Subject: MHI's Response to US-APWR DCD RAI No. 297-2287 Revision 2

MHI's Response to US-APWR DCD RAI No. 297-2287 Revision 2

**US-APWR Design Certification
Mitsubishi Heavy Industries
Docket No. 52-021**

RAI NO.: NO. 297-2287 REVISION 2
SRP SECTION: 15 – INTRODUCTION – TRANSIENT AND ACCIDENT ANALYSES
APPLICATION SECTION: 15.0.0
DATE OF RAI ISSUE: 5/04/2009

Figure 15.0.0-3.50 Radial Average Fuel Enthalpy versus Time with and without LOOP Rod Ejection (HZP, BOC)

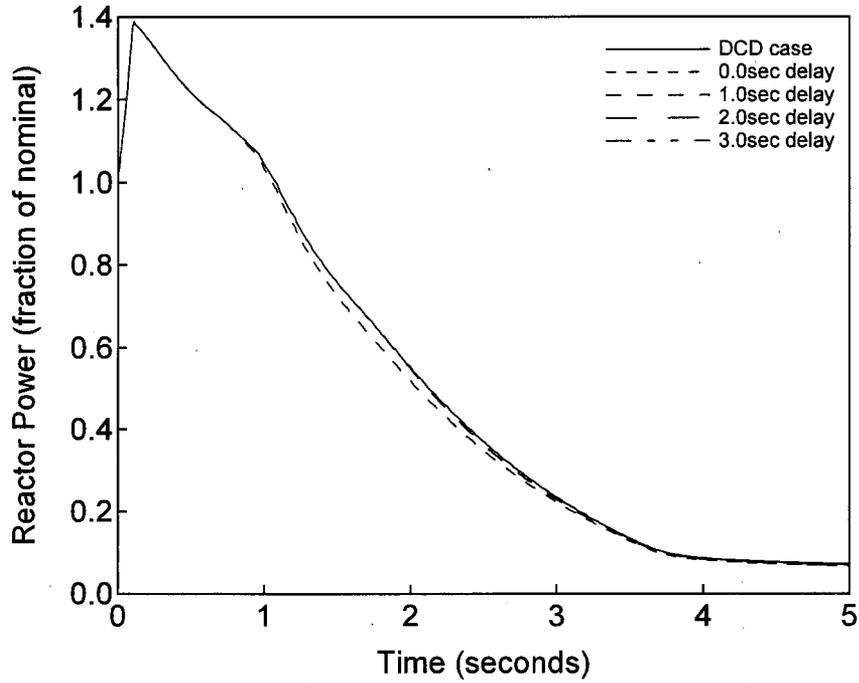
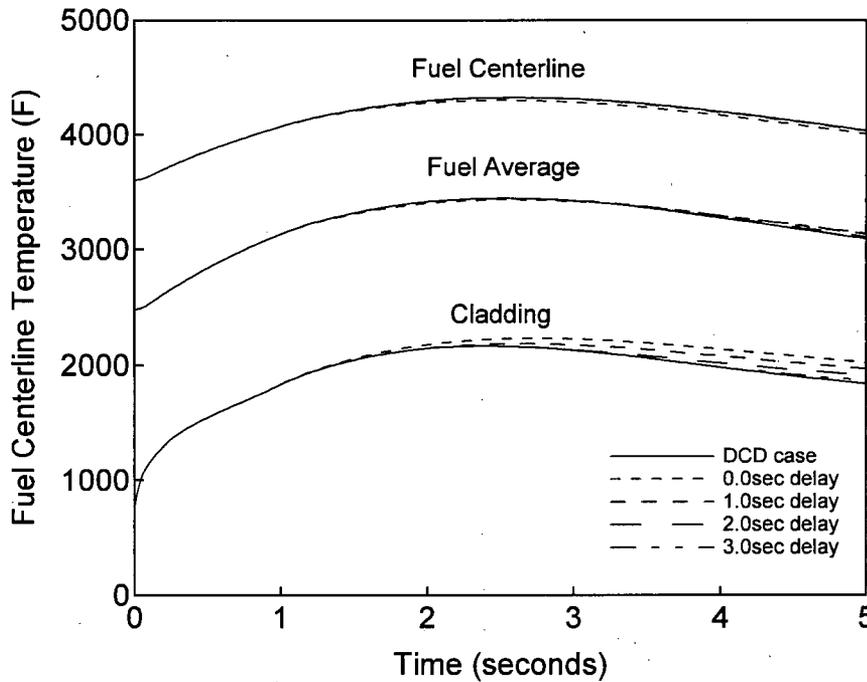
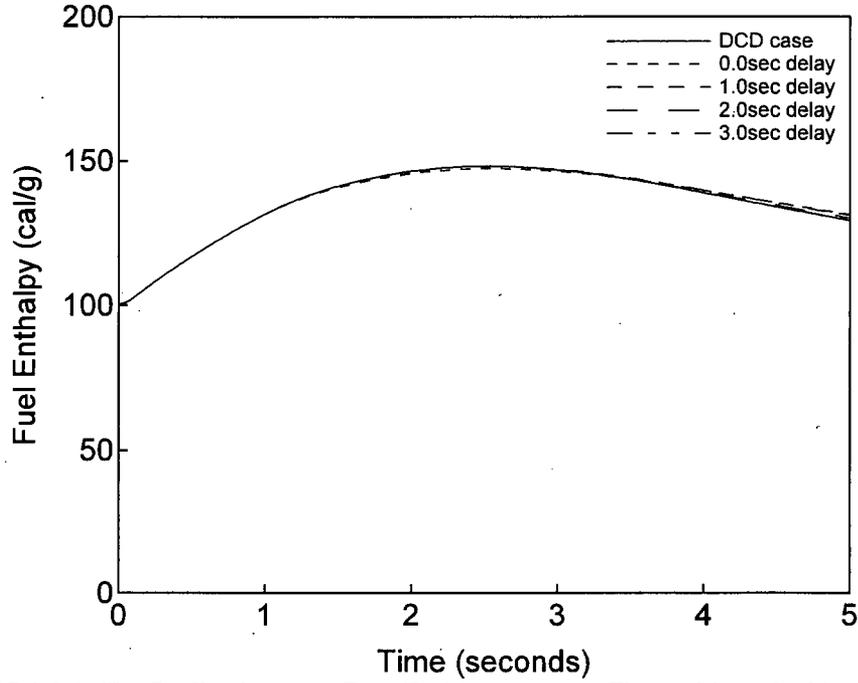
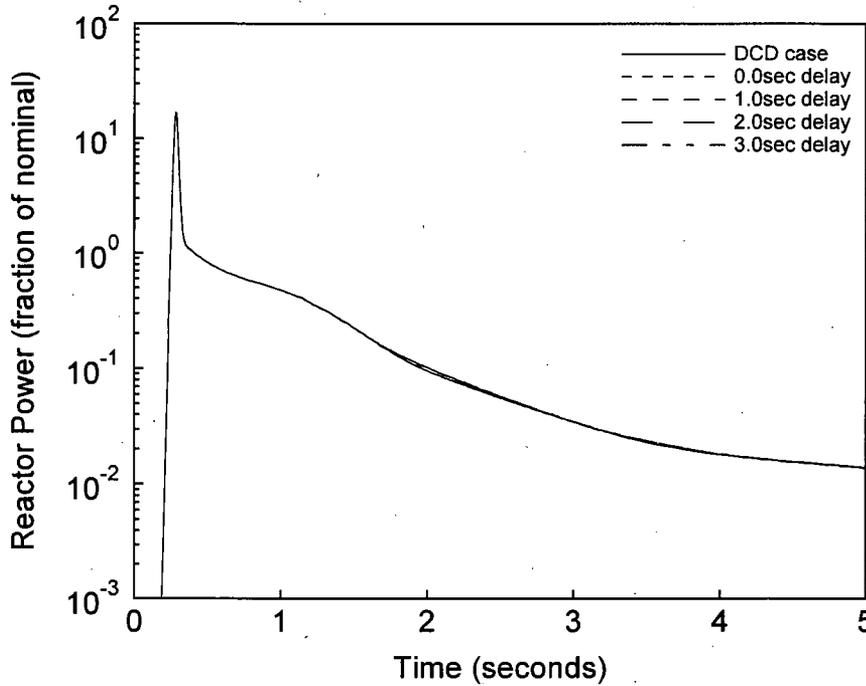
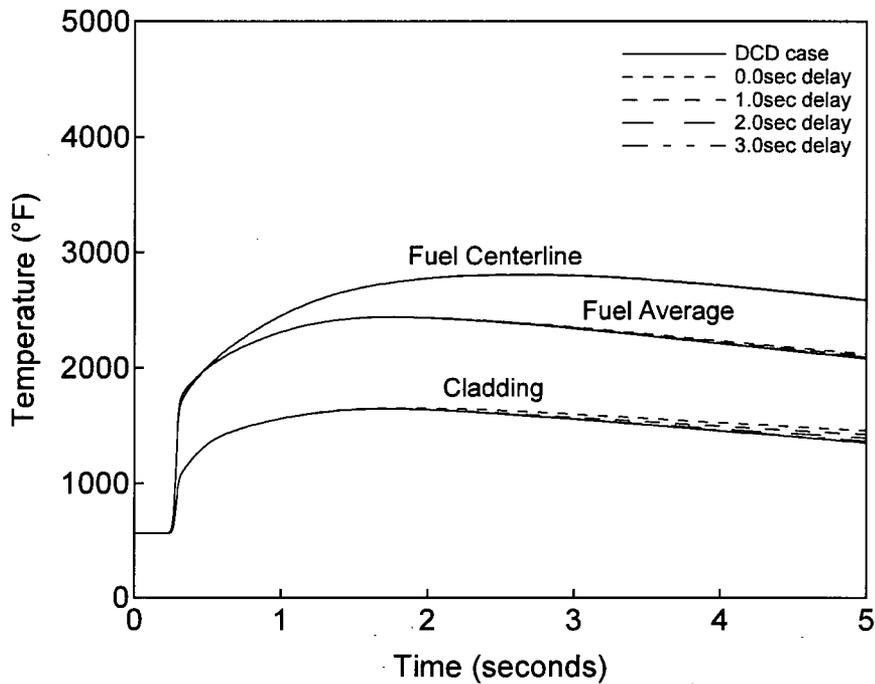
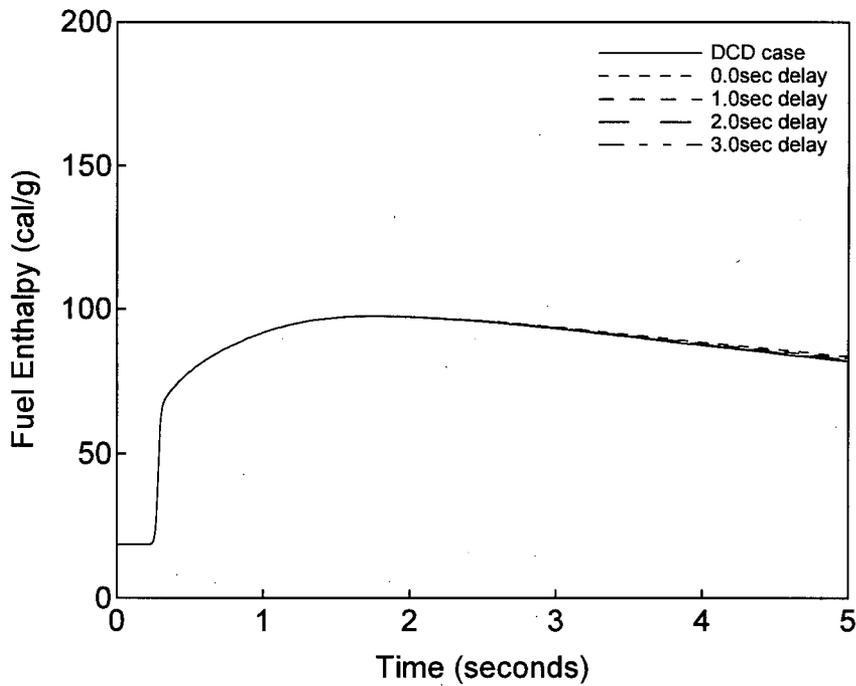
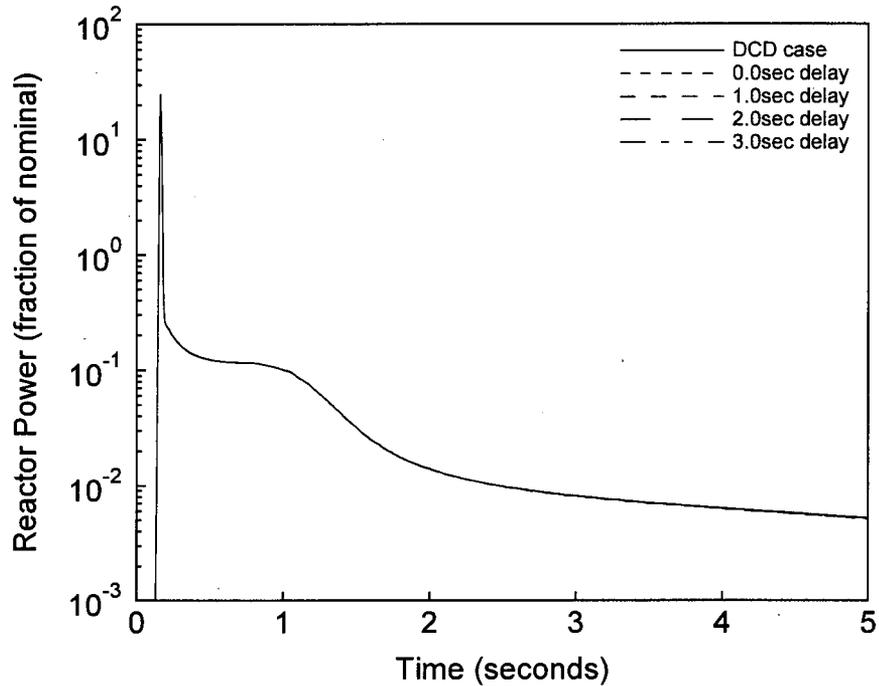
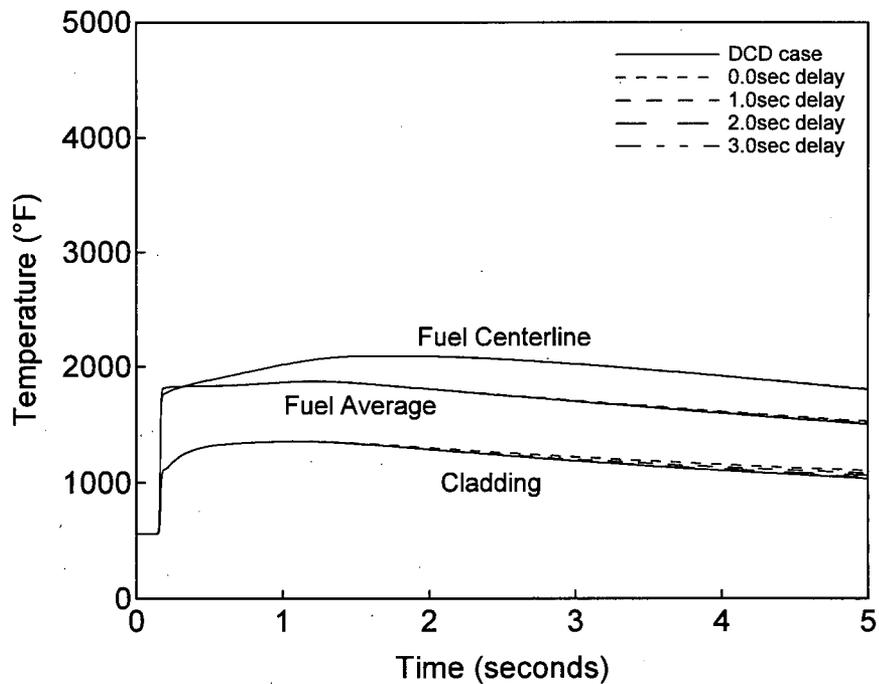
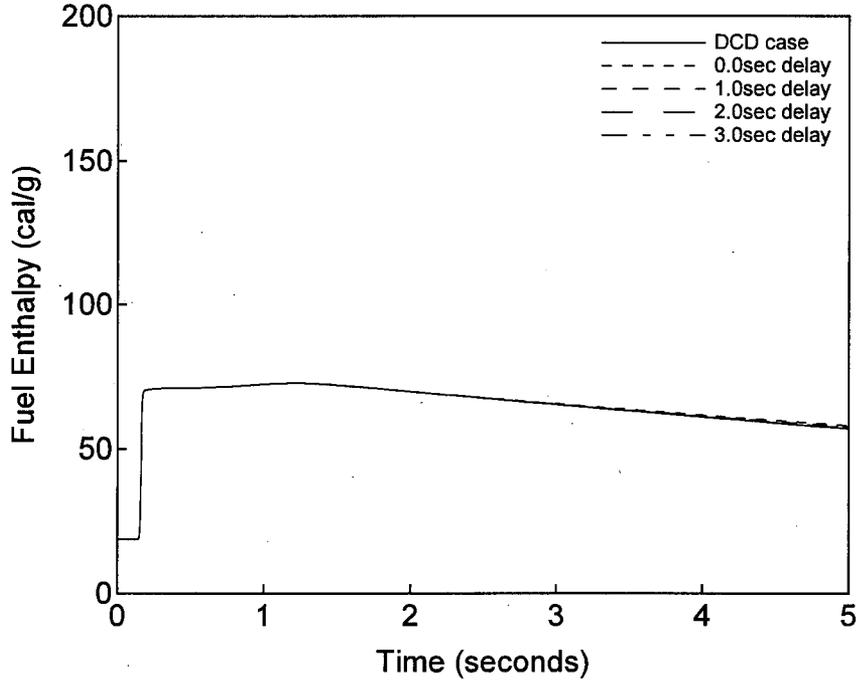
In DCD Section 15.0.0.7, the applicant presents arguments concerning the timing of a LOOP with respect to the timing of reactor trip and RCP coast down. By assuming a time delay in the onset of a LOOP, the onset of DNBR is decoupled from the availability of offsite power because the rods are inserted to the dashpot by the time the LOOP is initiated; therefore, the RCPs continue to run until the rods have been inserted in the core. This argument repeats itself throughout many Chapter 15 scenarios, allowing for the neglect of any LOOP consequences. Please provide more substantial arguments in defense of this assumed time delay, supported by sensitivity calculations that directly address this issue. (see also Question 15.1.2-1).

Three representative cases of the rod ejection event (Subsection 15.4.8) were evaluated to assess the impact of the assumed LOOP delay time on fuel parameters: hot full power (HFP) at end-of-cycle (EOC), hot zero power (HZP) at beginning-of-cycle (BOC), and HZP at EOC. The HFP-EOC case was evaluated to assess the impact of the LOOP assumptions on the calculated fuel centerline temperature. Figures 15.0.0-3.45 through 15.0.0-3.47 provide the transient results for the key analysis parameters for the rod ejection event at HFP-EOC conditions with LOOP. The calculated fuel centerline temperatures of all the LOOP cases are bounded by the fuel centerline temperature of the DCD case (no LOOP), as shown in Figure 15.0.0-3.46. The HZP-BOC and HZP-EOC cases were evaluated to assess the impact of the LOOP assumptions on the calculated fuel enthalpy. Figures 15.0.0-3.48 through 15.0.0-3.50 and Figures 15.0.0-3.51 through 15.0.0-3.53 provide the transient results for the key analysis parameters for the rod ejection event at HZP for BOC and EOC conditions, respectively, with LOOP. The calculated peak fuel enthalpies of all of the LOOP cases are bounded by peak fuel enthalpy of the DCD case (no LOOP) as shown in Figures 15.0.0.3-50, and 15.0.0.3-53.
